FACTORY MANCHESTER

Approved North Elevation - Planning Permission Ref. 119890/VO/2019

P11	D2	31 Mar 2021	PLANNING UPDATE
P10	D2	10 Mar 2020	THEATRE FACADE FIRST STAGE TENDER
P9	S2	19 Nov 2018	ISSUED FOR INFORMATION
P8	S2	23 Mar 2018	ISSUED FOR PLANNING
P7	S3	15 Mar 2018	INTERIM DESIGN RELEASE
P6	S0	21 Dec 2017	WIP INTERIM GA SUBMISSION
REV	STAT	DATE	DESCRIPTION

PROPOSED NORTH ELEVATION

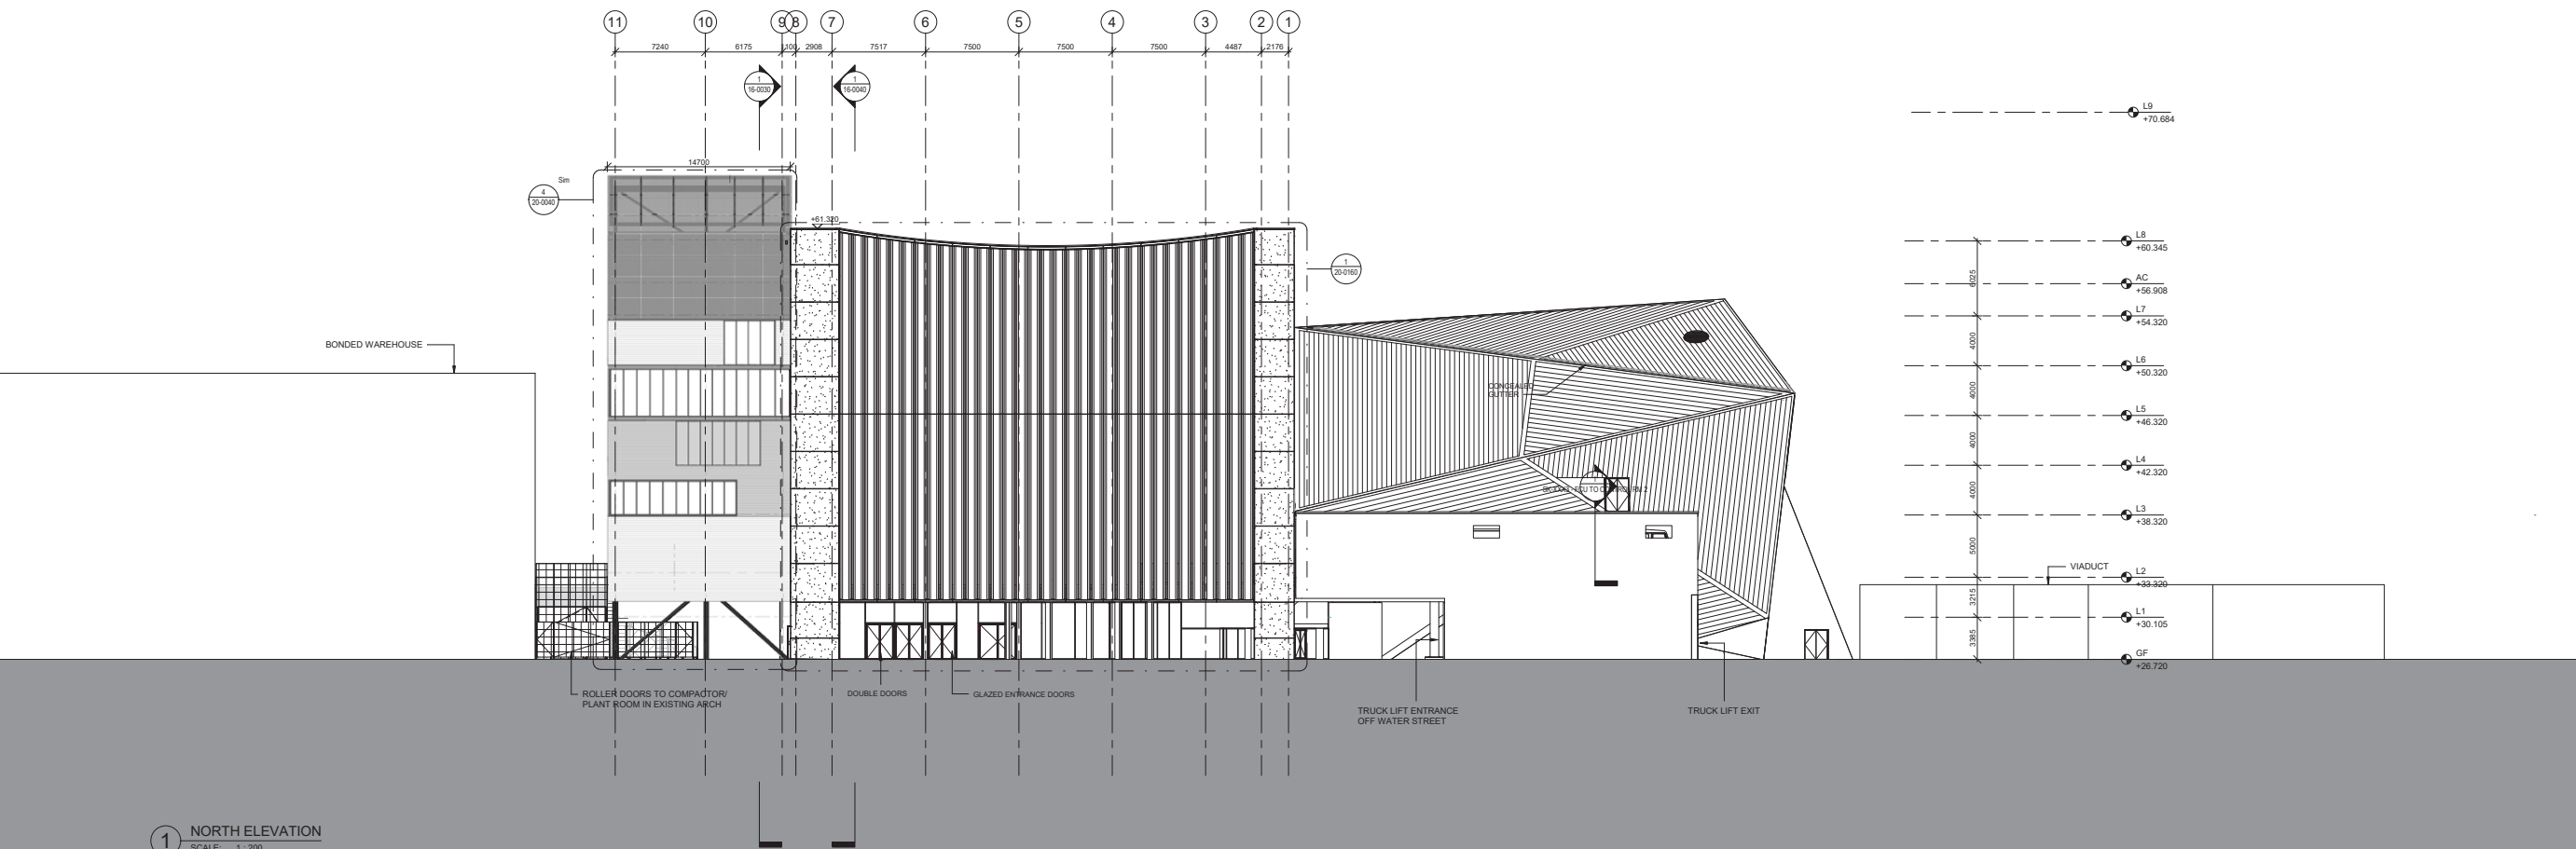
- c. change from vertical to horizontal orientation of sinusoidal cladding
- d. change of channel glass to fritted translucent curtain wall
- e. change of metal mesh from elephant grid to expanded metal mesh

1 EAST ELEVATION
SCALE: 1:200

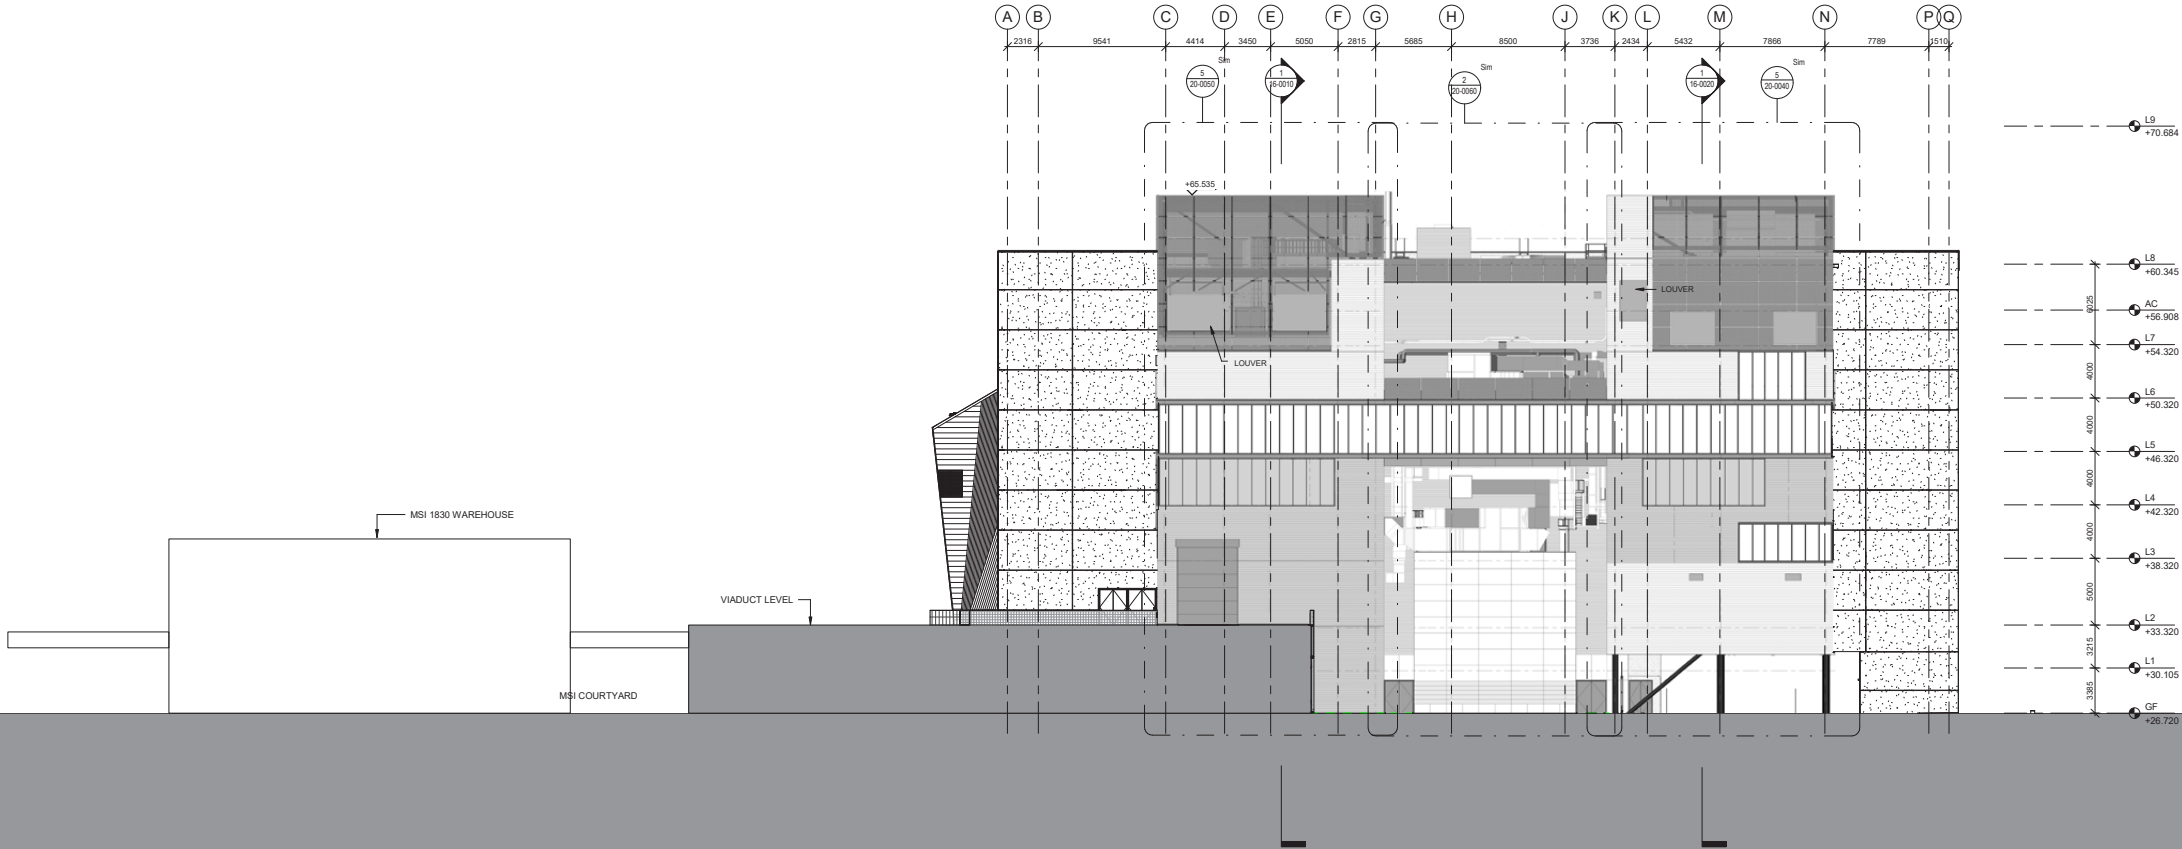
a. change to cladding type at theatre from single-ply to standing seam (behind warehouse)

c. change from vertical to horizontal orientation of sinusoidal cladding

d. change of channel glass to fritted translucent curtain wall

e. change of metal mesh from elephant grid to expanded metal mesh

1 SOUTH ELEVATION
SCALE: 1:200

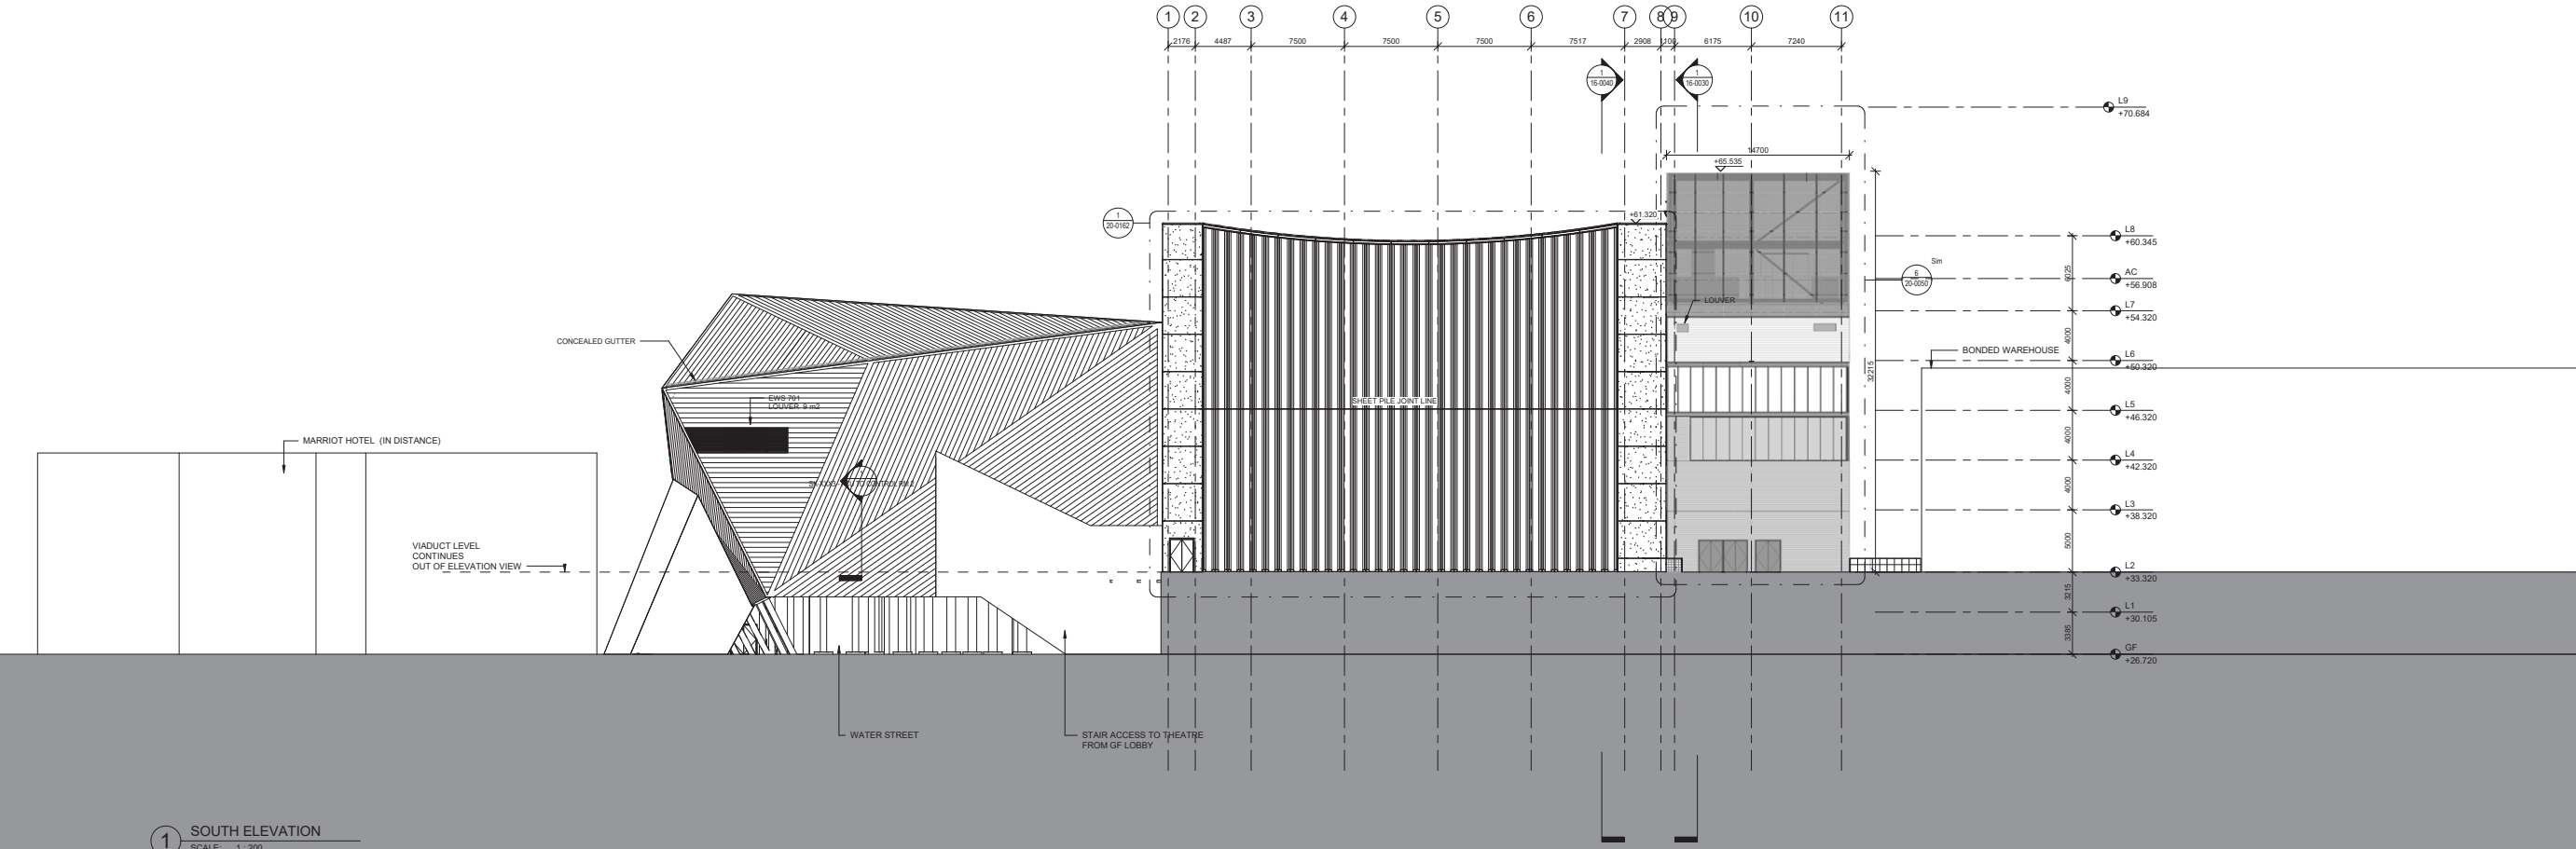
- a. change to cladding type at theatre from single-ply to standing seam
- b. shape of louvre adjusted

- c. change from vertical to horizontal orientation of sinusoidal cladding
- d. change of channel glass to fritted translucent curtain wall
- e. change of metal mesh from elephant grid to expanded metal mesh

1 WEST ELEVATION
SCALE: 1:200

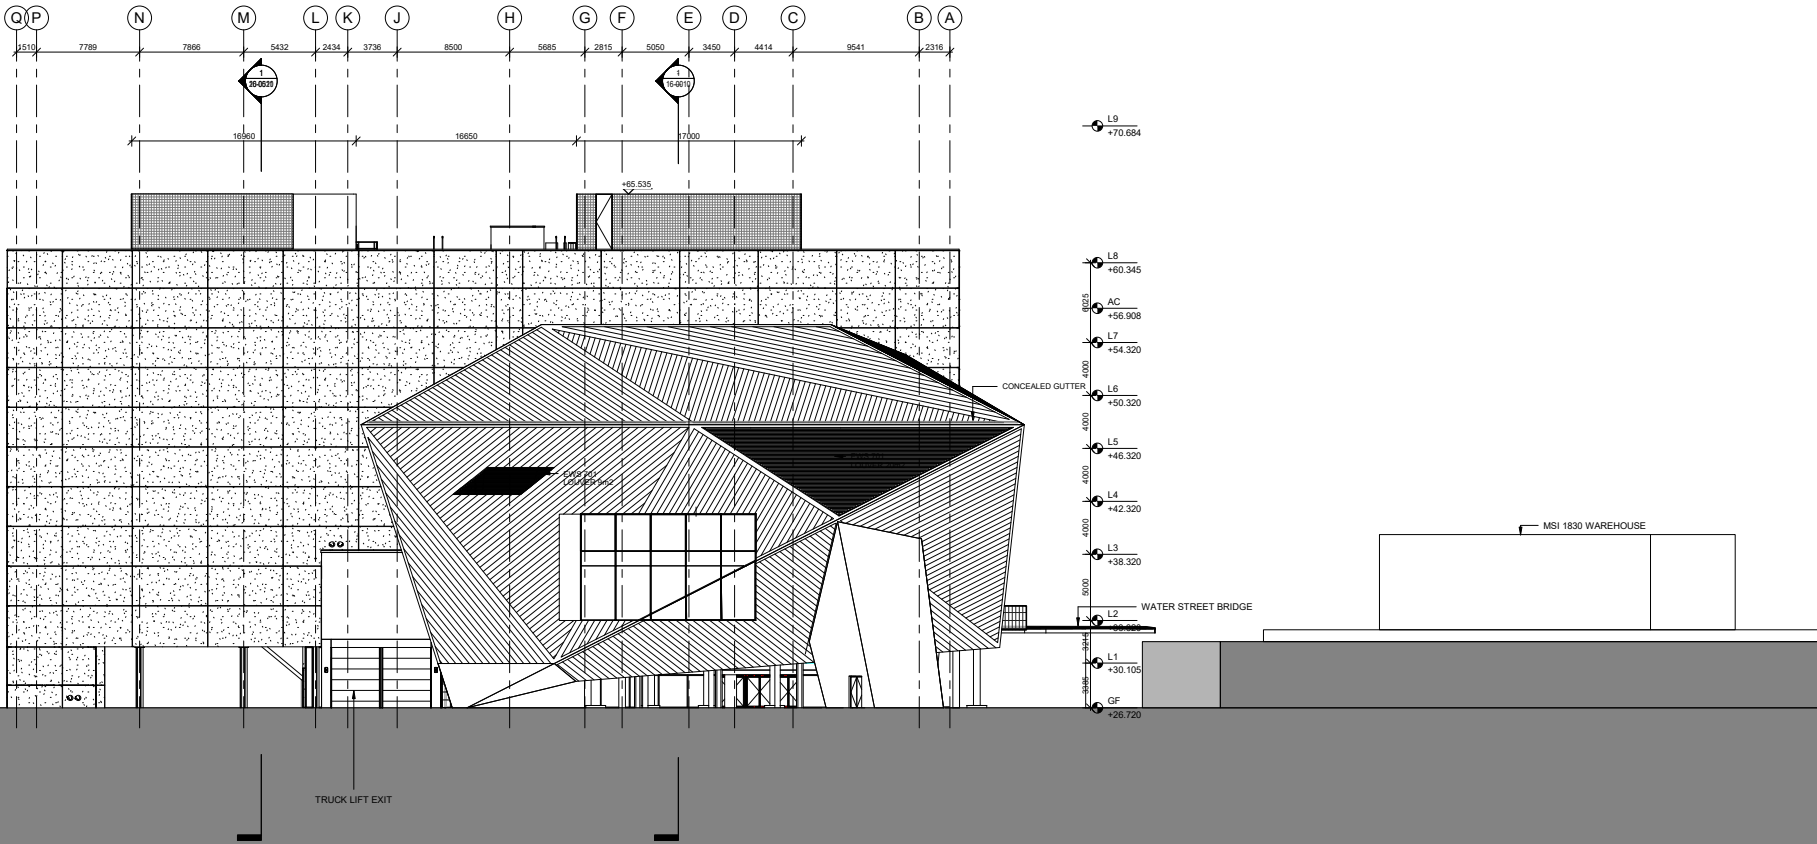
- a. change to cladding type at theatre from single-ply to standing seam
- b. change to cladding of trucklift from expanded metal mesh to cast in place concrete
- c. adjusted louvre shape, location
